# Texas Commission on Environmental Quality

## Attachment 2 – NOD Responses

Municipal Solid Waste Permit Amendment No. 1848A  
 Beck Landfill  
 6<sup>th</sup> Notice of Technical Deficiency

BECK LANDFILL  
GUADALUPE COUNTY, TEXAS  
TCEQ PERMIT APPLICATION NO. MSW 1848A

## BECK LANDFILL Bore Hole Location & Data Schertz, TX

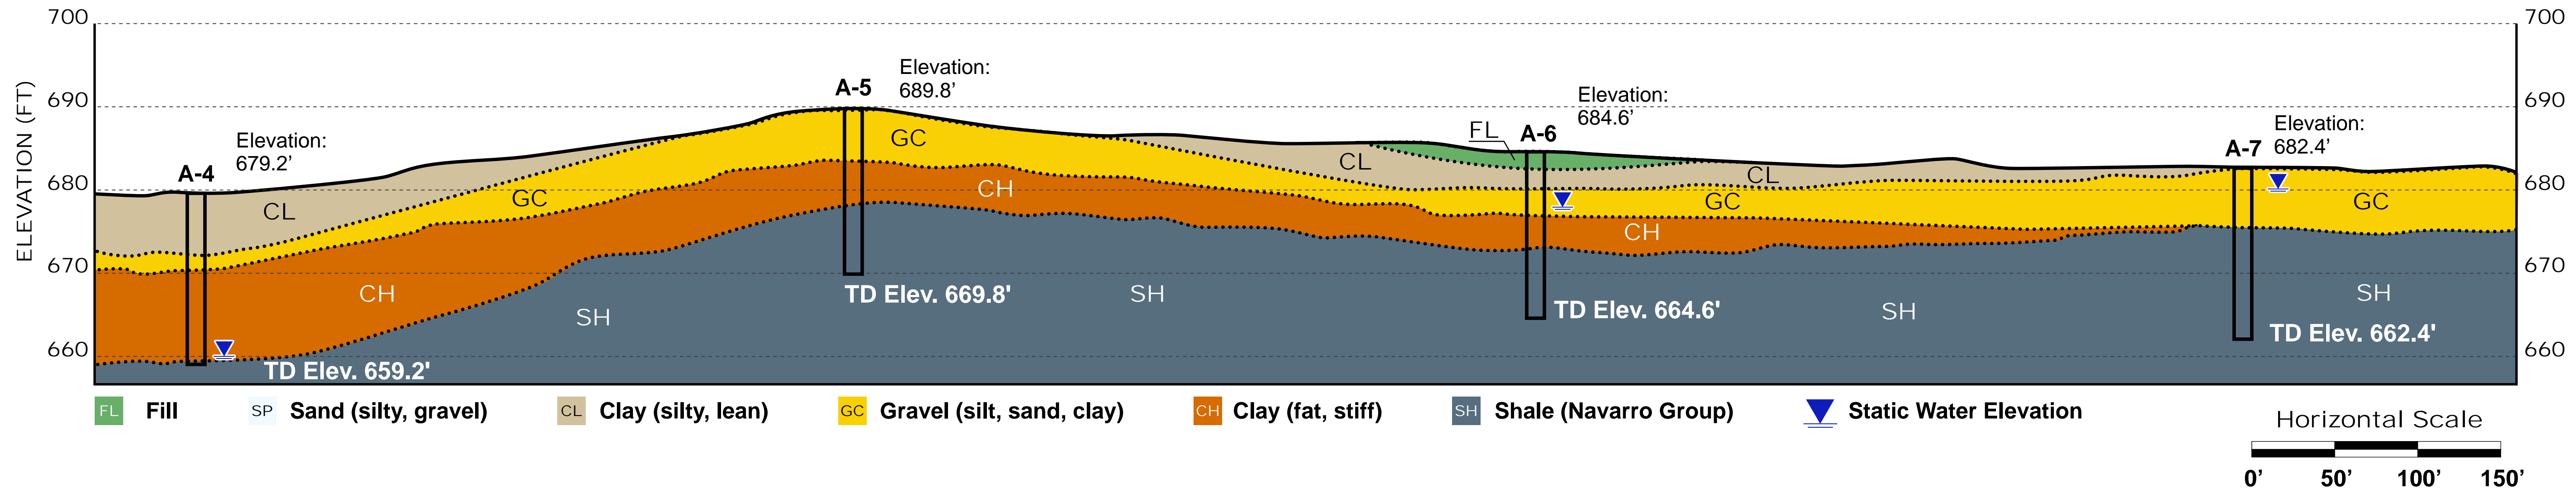
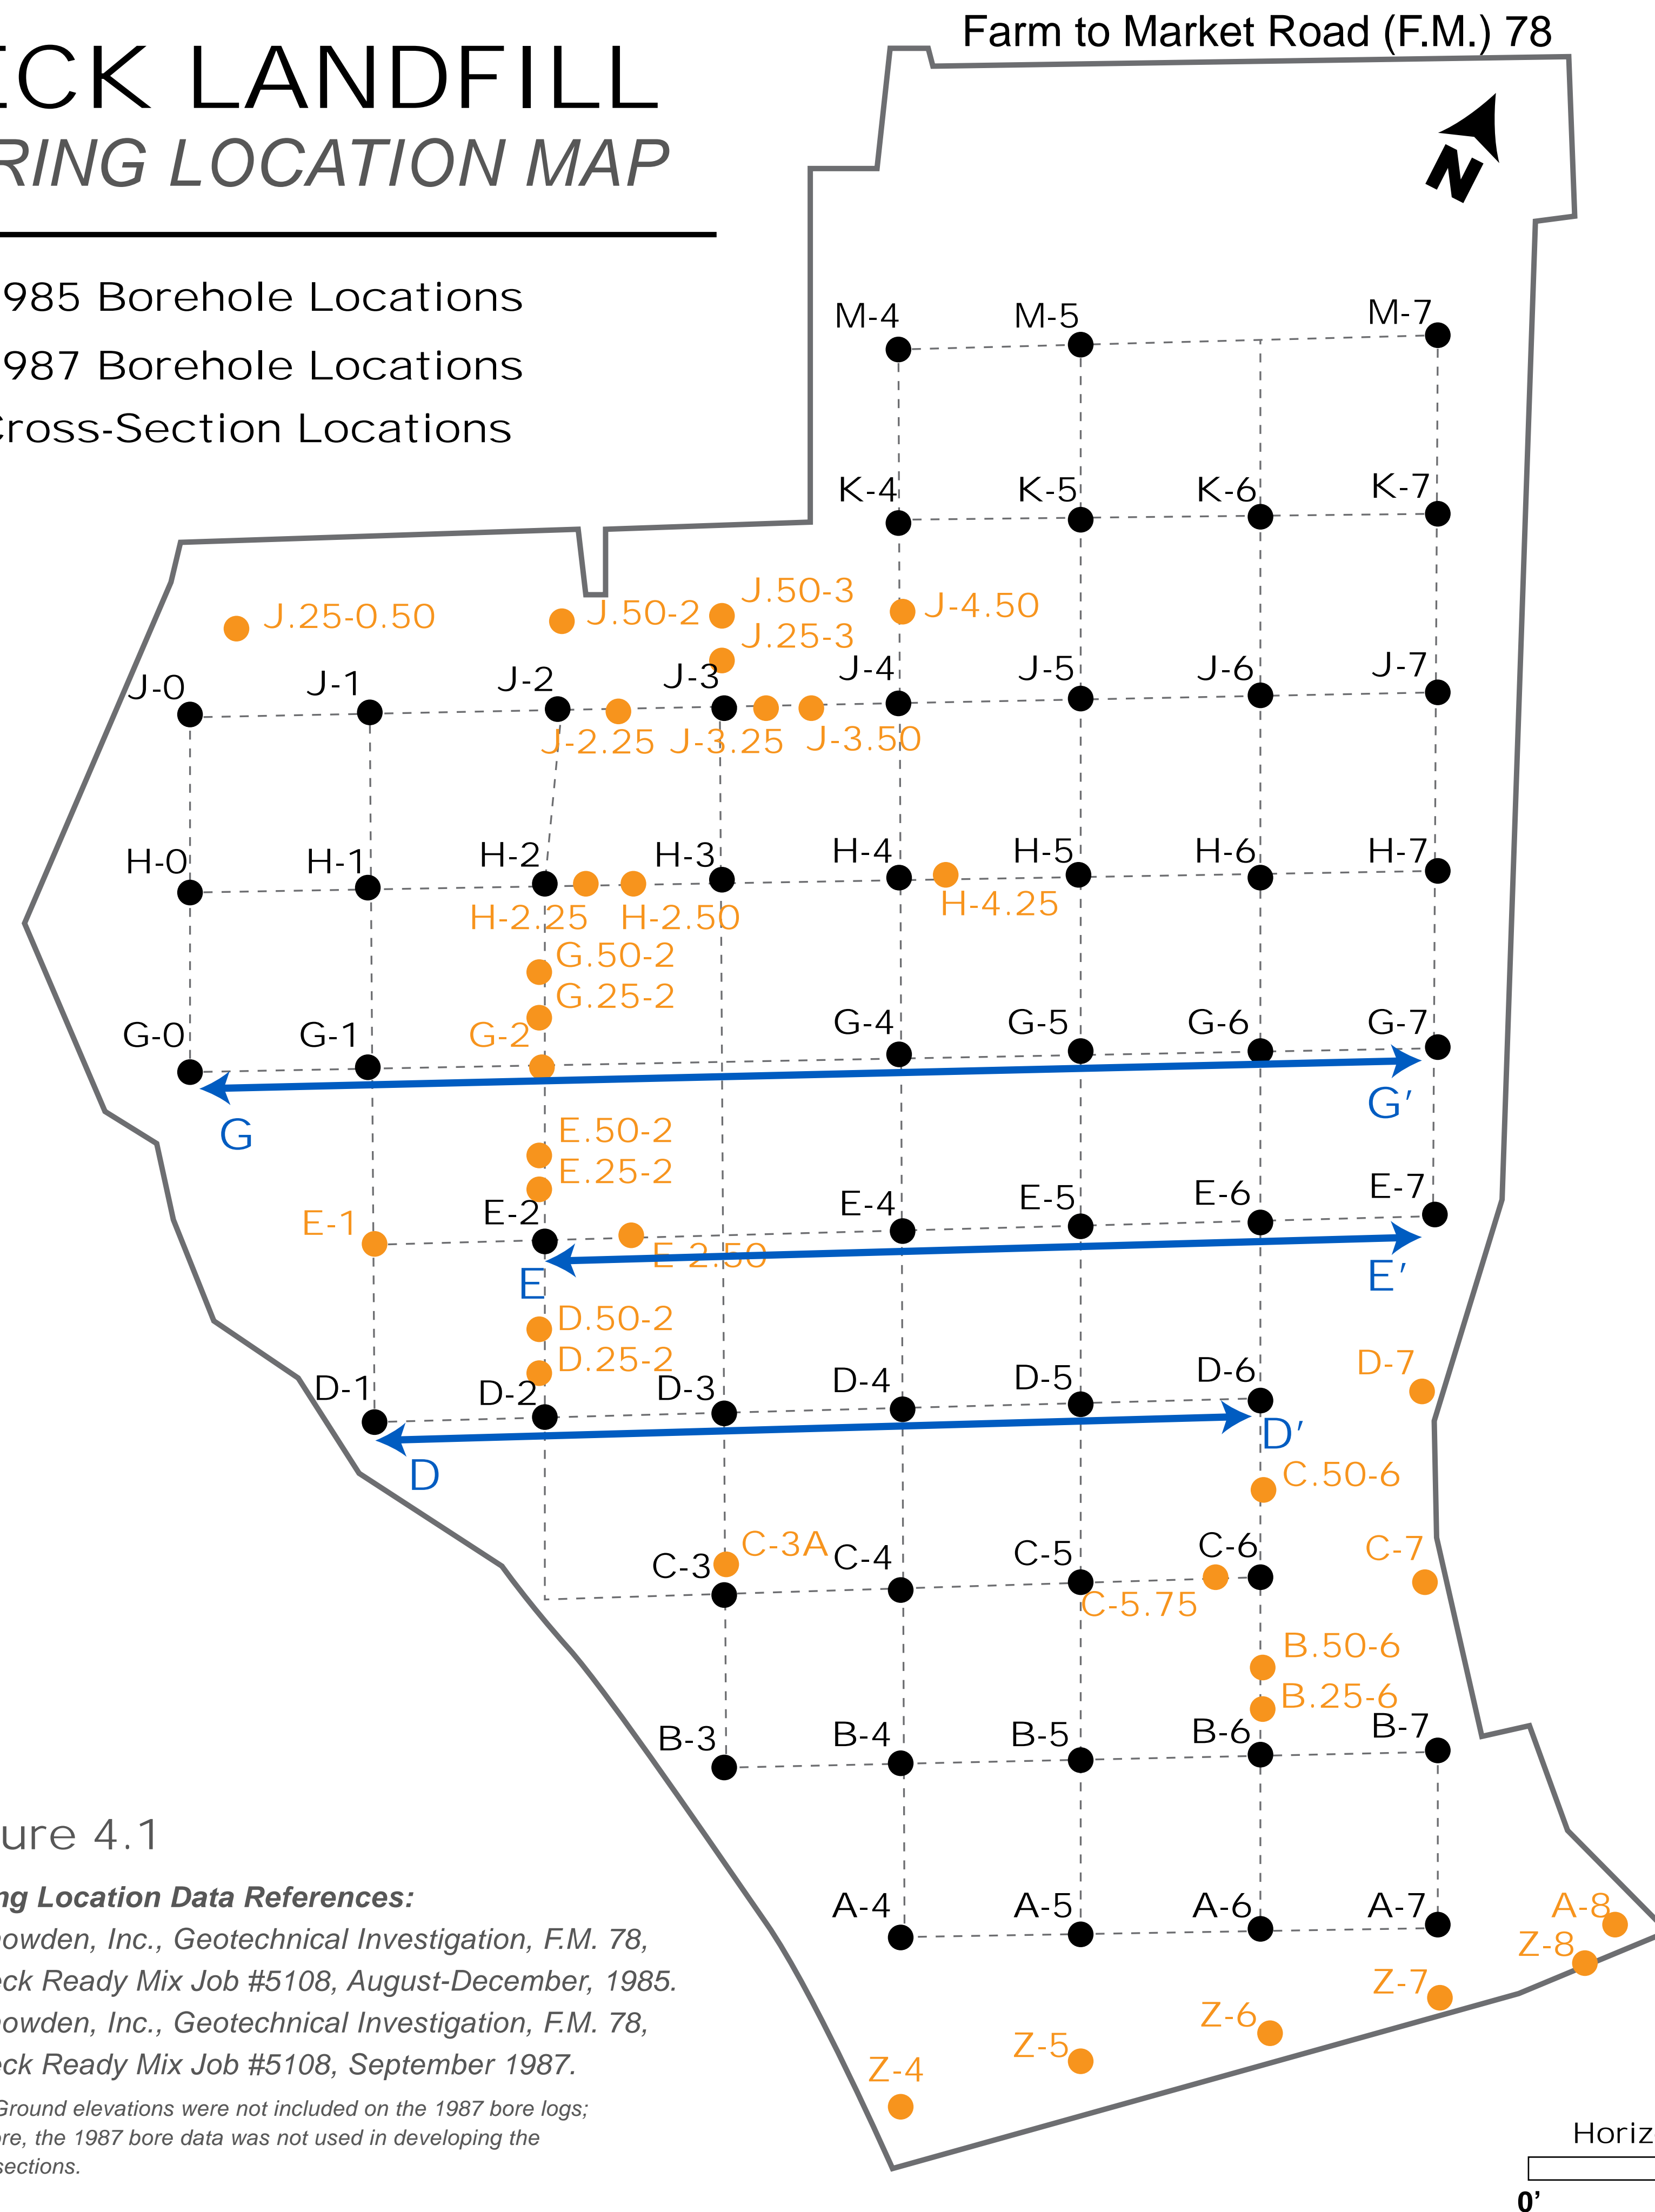
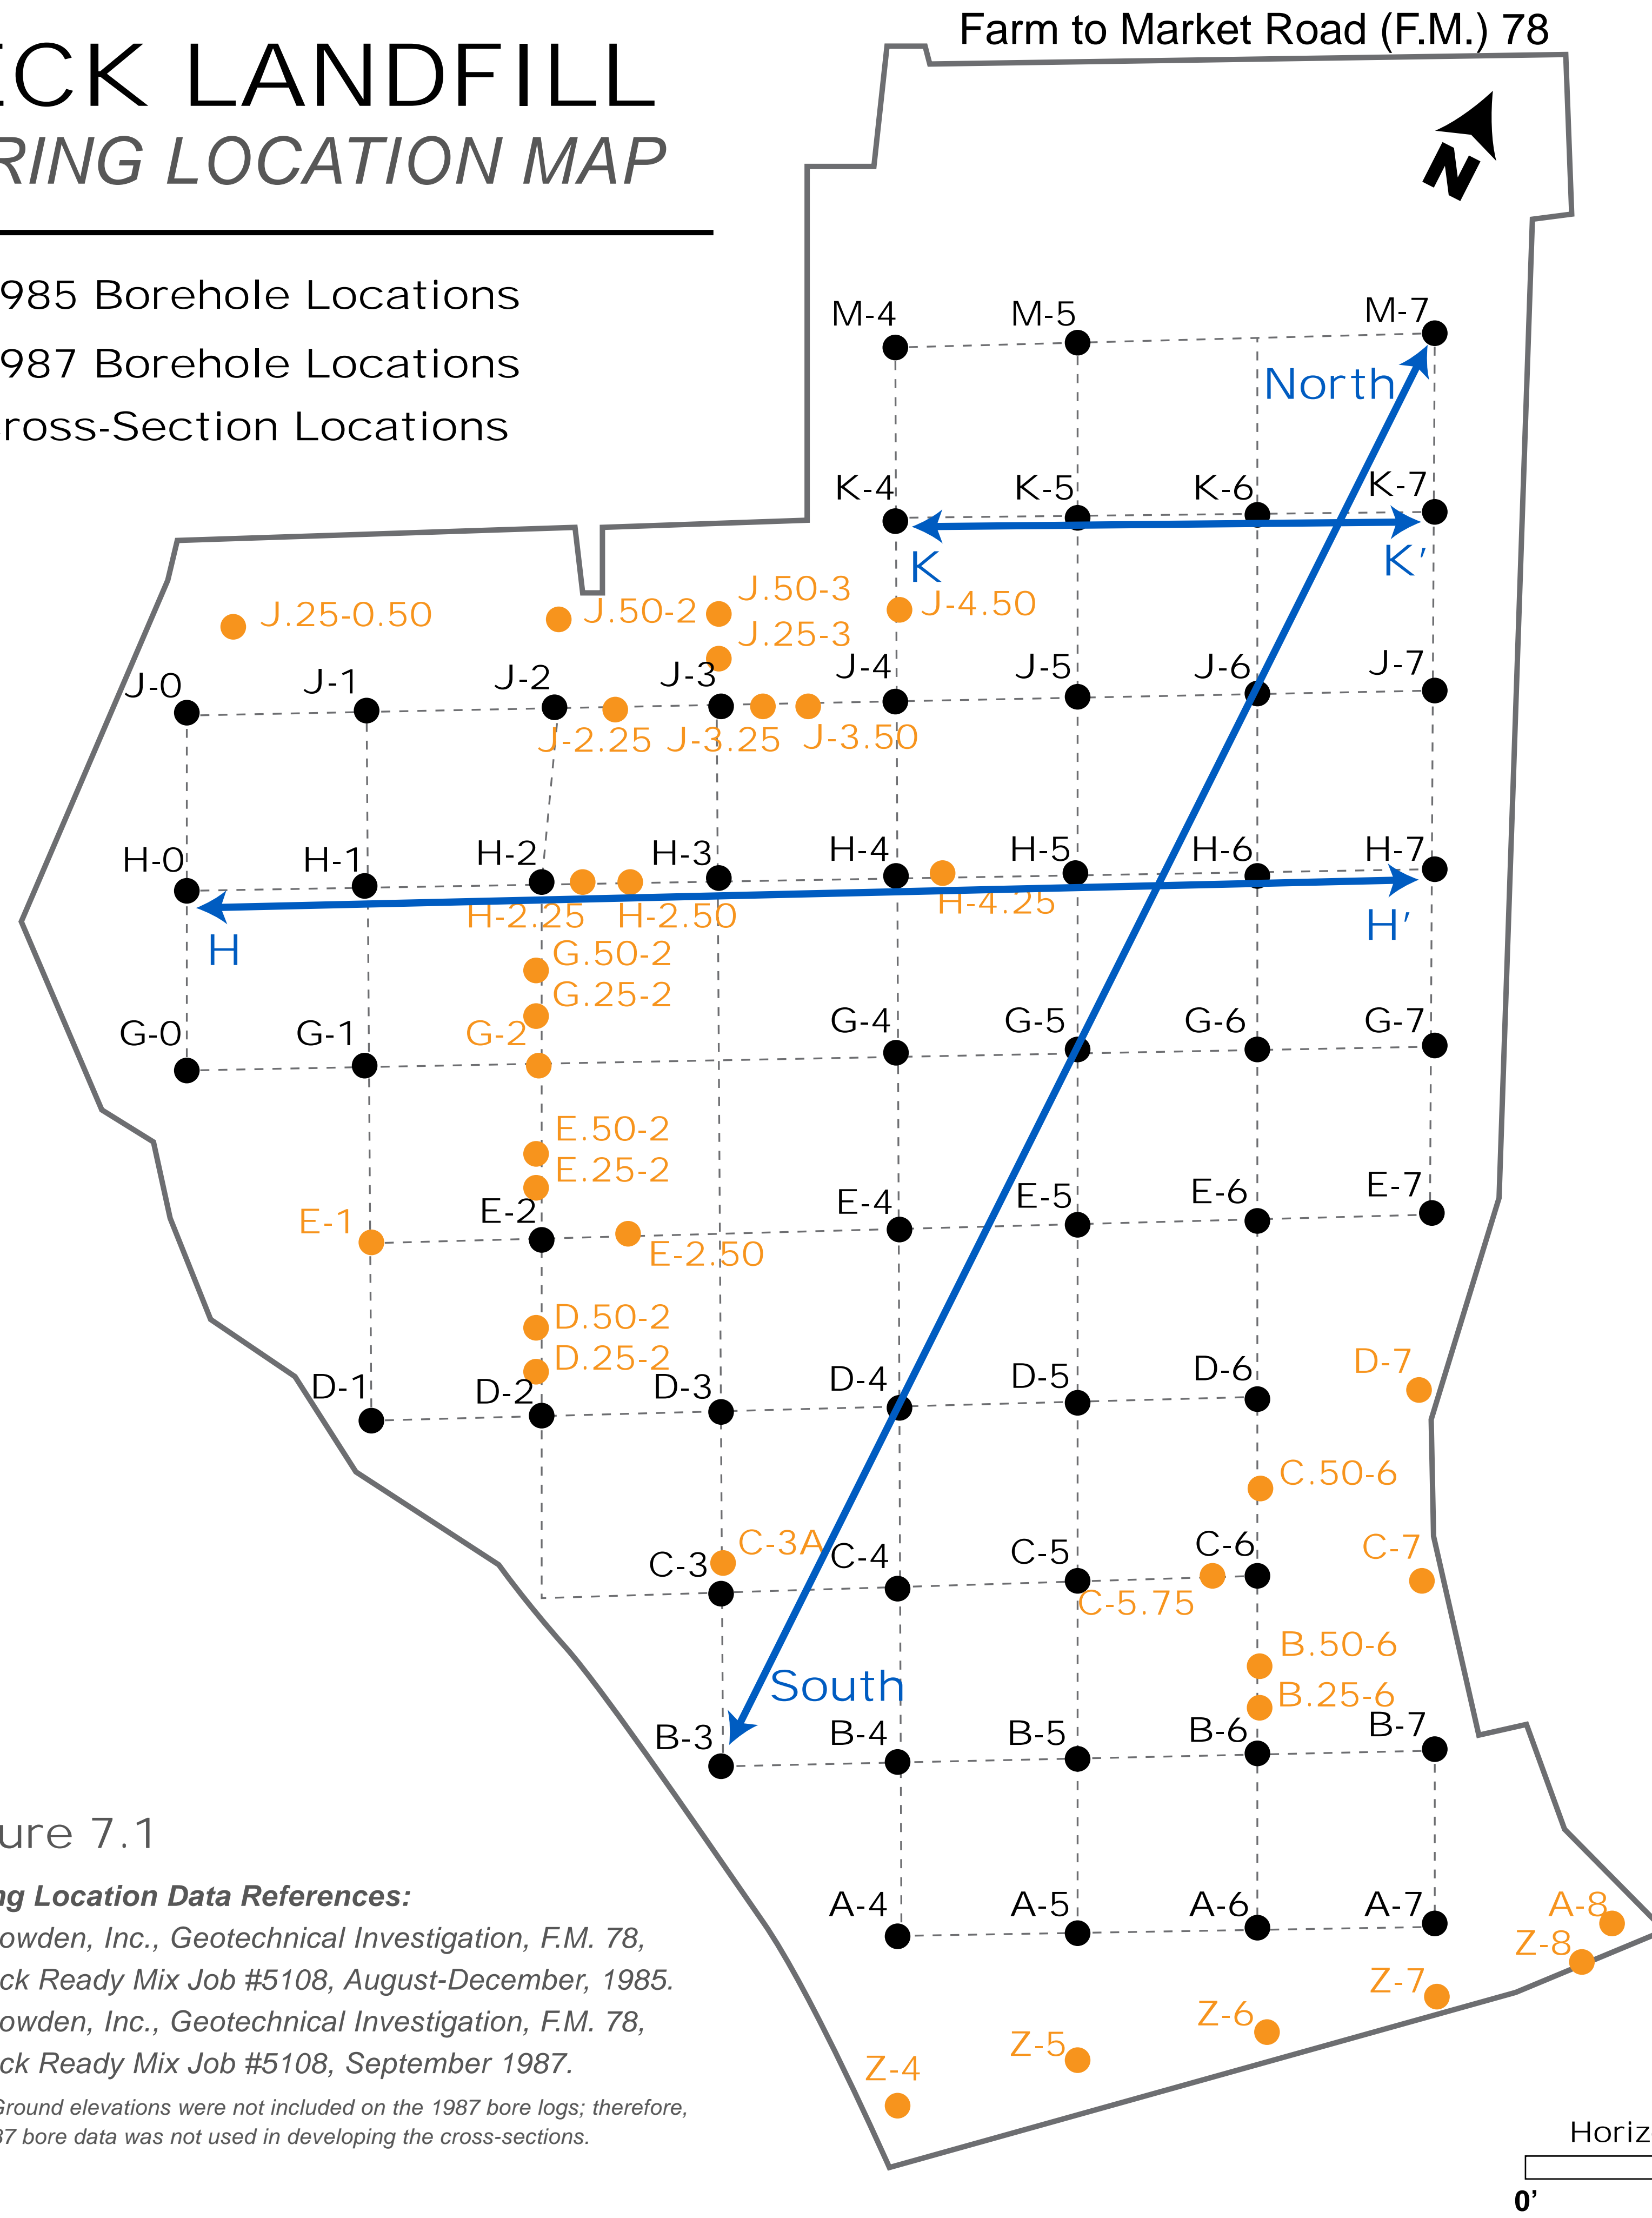
| NOD ID | MRI ID | Citation        | Location   | NOD Description  | Response  |
|--------|--------|-----------------|--|--|---|
| 7      | 494    | 330.63(e)(4)(G) | Part III, Attachment E, Appendix E-3, Cross Sections | <p>a. Change the color of the boring location symbols for borings C-7, D-7, and E-1 to orange to indicate they are 1987 borehole locations.</p> <p>b. Provide boring log for boring E-2.5.</p> | <p>Changed the color of C—7, D-7, and E-1 to orange to indicate they are 1987 borehole locations.</p> <p>C7, D7 and E1 (1987 boring) were removed from the cross-sections and Figures 1-2 and 4-2. Borehole E-2.5 was removed from Figure 4-2. 1987 borehole data was removed from the cross-sections to eliminate uncertainty regarding the starting elevation of the borings. Removing these boreholes did not change the cross sections and ensures a higher degree of factual information to the cross sections provided.</p> <p>All borings advanced are shown on the figures, for references and remain included in Part III, Attachment D, Appendix D5-C3.</p> |
| 9      | 29     | 330.57(h)(4)(B) | Part III, Attachment E, Appendix E-3, Cross Sections | Add bar scales to the boring location maps on pages 1, 4, 7, and 10 in Appendix E-3.   | Bar scales were added to pages 1, 4, 7 and 10.  |
